Enclosed please find Arlington County staff comments on the VDOT Route 1 Multimodal Improvements Study Phase 2 details presented to date. We appreciate the opportunity to provide a thorough review of how the VDOT Route 1 Concept Plan and streetscape alternatives align with the Crystal City Sector Plan (CCSP), other Board-adopted plans and policies, and ongoing projects and private development nearby.

Arlington County Comments on VDOT Route 1 Multimodal Improvements Study Phase 2

Opportunities for Improved Alignment between VDOT Concepts and County Plans

Figure 1. Recommended cross-section from 23rd Street to 18th Street.

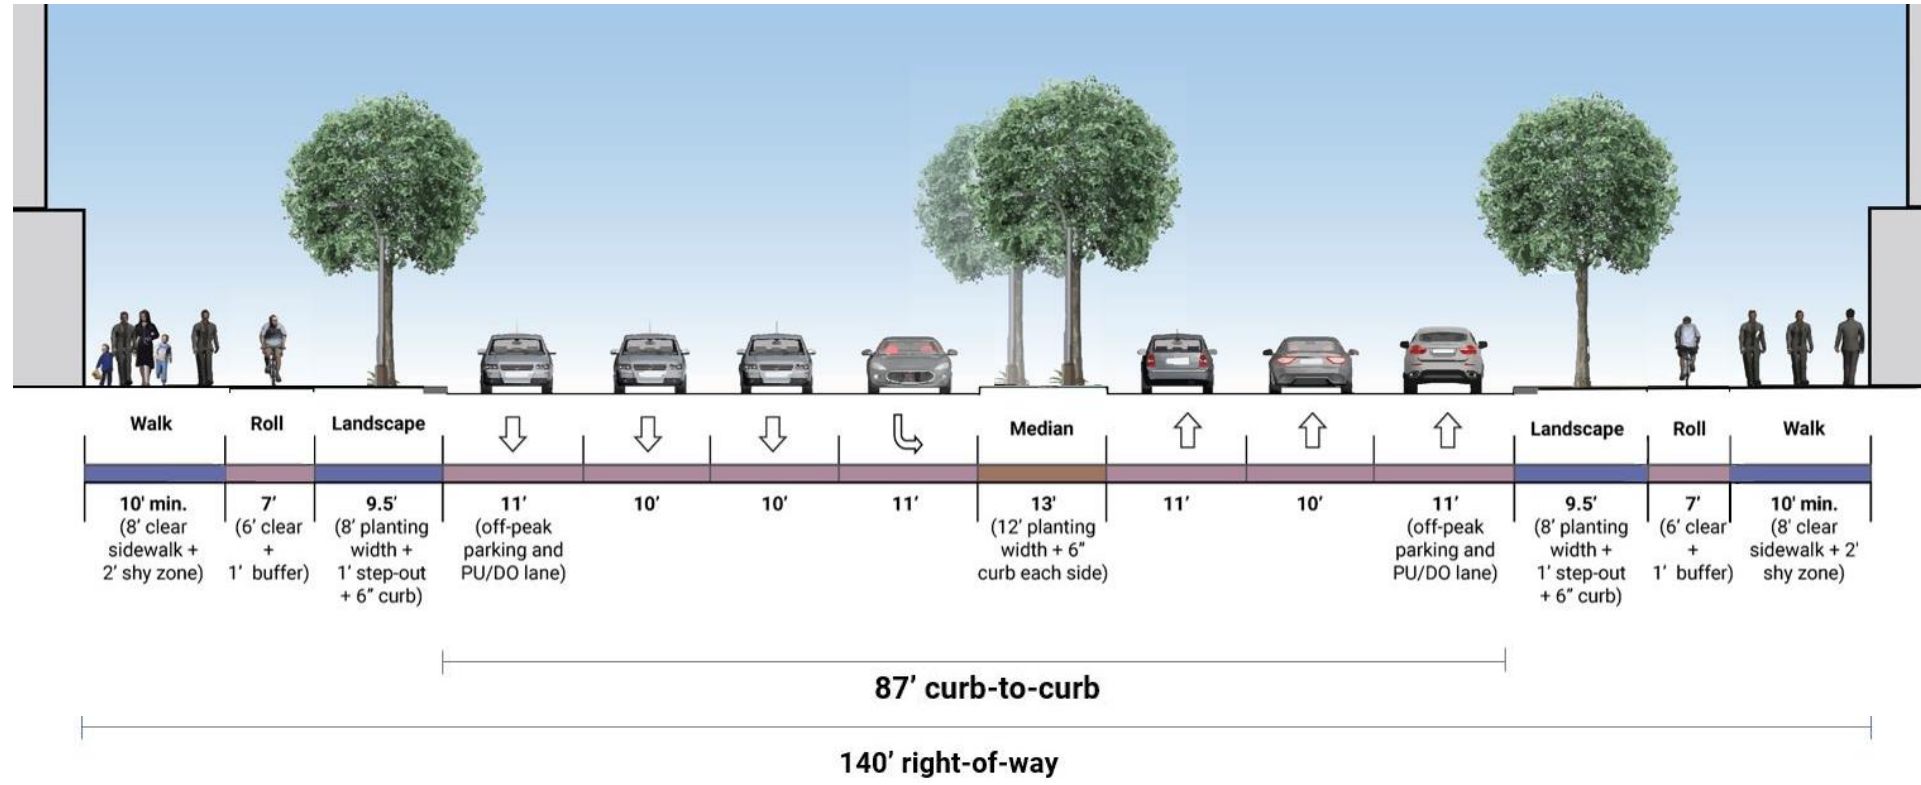
- a. Follow the right-of-way recommendations outlined in the CCSP, which account for right-of-way constraints and development patterns south of 18th Street and wider available right-of-way north of 18th Street:

- a. 140' from 23rd Street to 18th Street and
 - b. Up to 160' north of 18th Street, to accomplish minimum recommendations described in the following sections.
- b. Maintain a consistent curb-to-curb width of 87 feet from 12th Street to 23rd Street, as shown in Figures 1 and 2, with the remaining width dedicated to streetscape elements behind the curb. North of 18th Street, use the additional width to provide the wider cross-section shown in Figure 2. This is feasible without impacting the land development potential to the east and northwest of Route 1 at 15th Street, as envisioned in the Sector Plan.

Figure 3. Relocating the sidewalk creates opportunity for improved pedestrian comfort approaching 12th Street

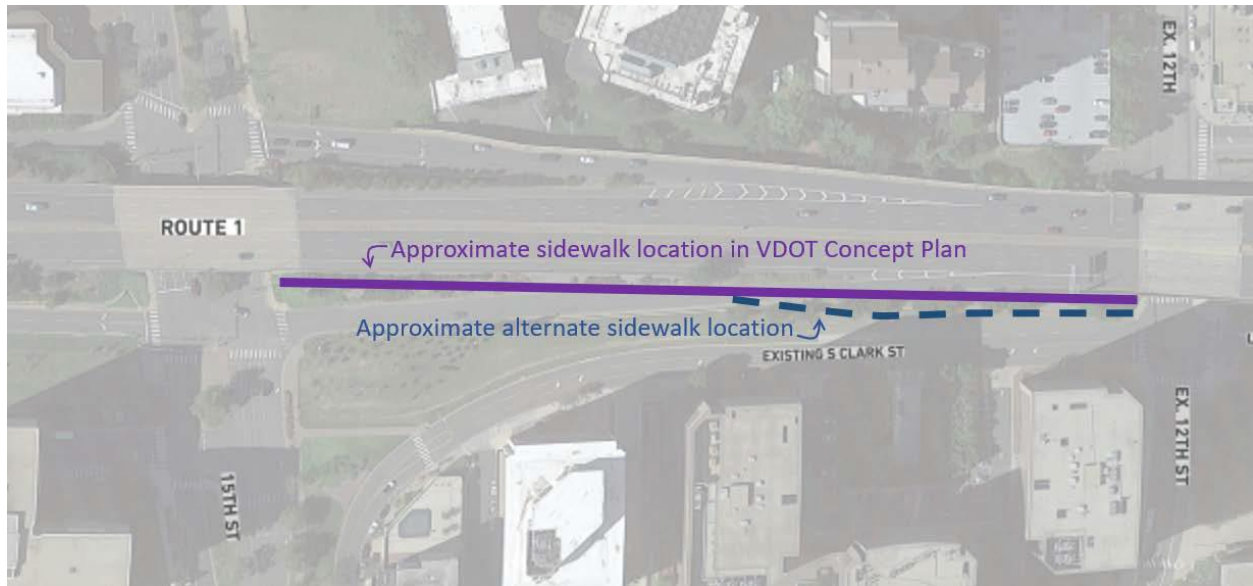
- b. The VDOT Concept Design Plan envisions that Route 1 is elevated over 12th Street and transitions to at-grade at the intersection with 15th Street. The transition zone between 12th Street and 15th Street will require retaining walls between the sidewalk (which will remain at grade) and the roadway as it elevates. Special attention is appropriate in this portion of the corridor to ensure the comfort and personal safety of people walking along these sidewalks. On both sides of Route 1, additional pedestrian-scale lighting is recommended. On the east side of Route 1, a wider landscaped space between the retaining wall and the sidewalk would create a more comfortable experience for people walking. This could be achieved by shifting the alignment of the east-side sidewalk to adjoin Clark Street, as shown in Figure 3. One key design consideration is that the County's 15th Street South / S Clark Street Realignment Project will start construction in 2023 and is expected to be complete prior to Route 1 implementation. The sidewalk alignment along Route 1 should tie into the County's project as an existing condition.

Figure 5a. VDOT’s median cap design at the intersections of Route 1 and 20th and 15th Streets.

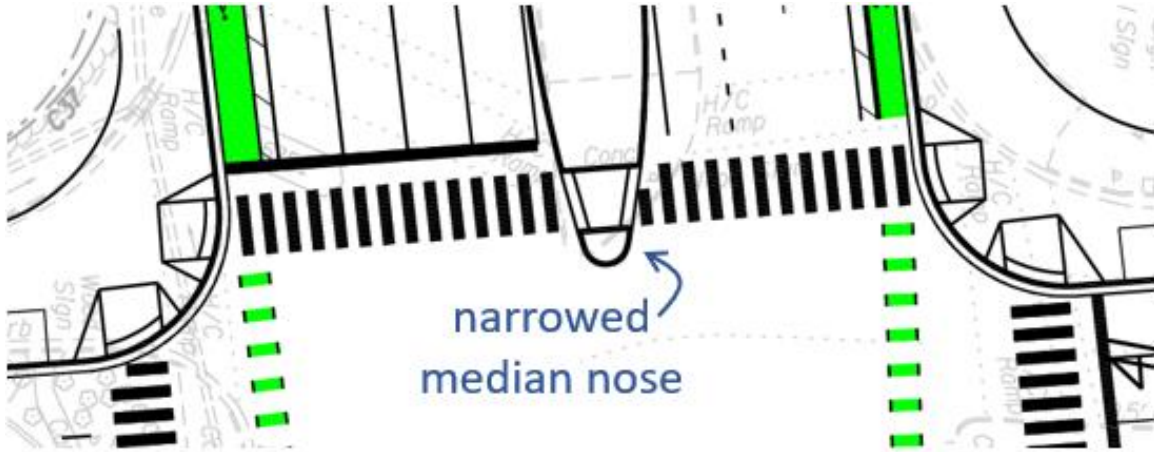
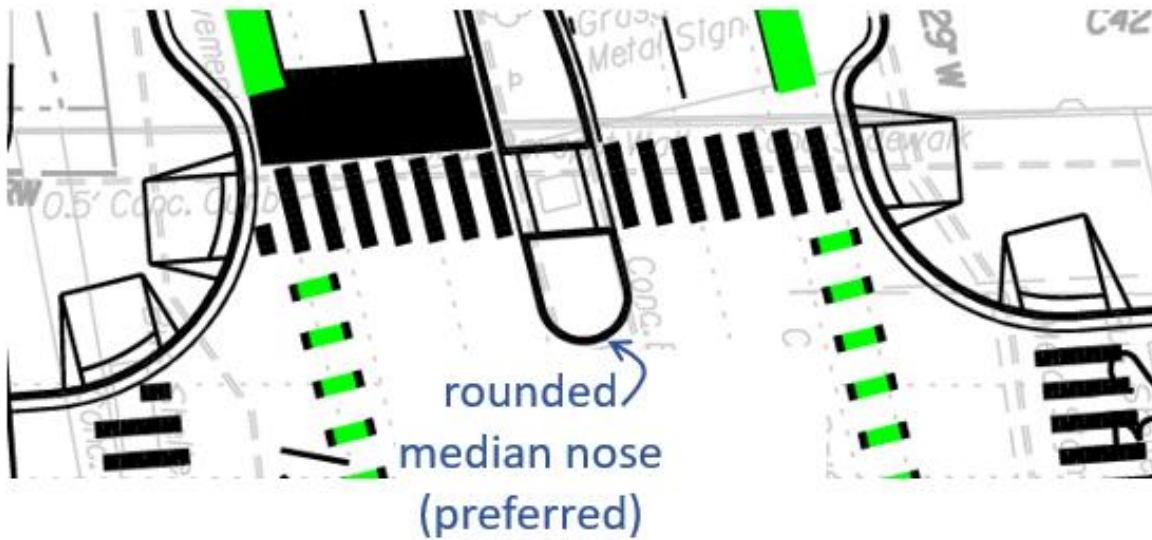
- f. Include rounded median noses at all intersections. The current VDOT Concept Design Plan shows narrowed median noses at the intersections of Route 1 and 20th Street as well as at 15th Street. The design should use Arlington County's Guidelines for the Design and Treatment of Median Noses (Version 1, 2019). With three receiving lanes for turning vehicles, narrowed medians are not necessary to accommodate turning vehicles. As described in the County's guidelines, wider median noses (as shown in Figure 5) provide a better sense of enclosure for pedestrians crossing the street and help to position turning vehicles at closer to a 90-degree angle to the crosswalk, which gives the drivers a better view of the crosswalk.
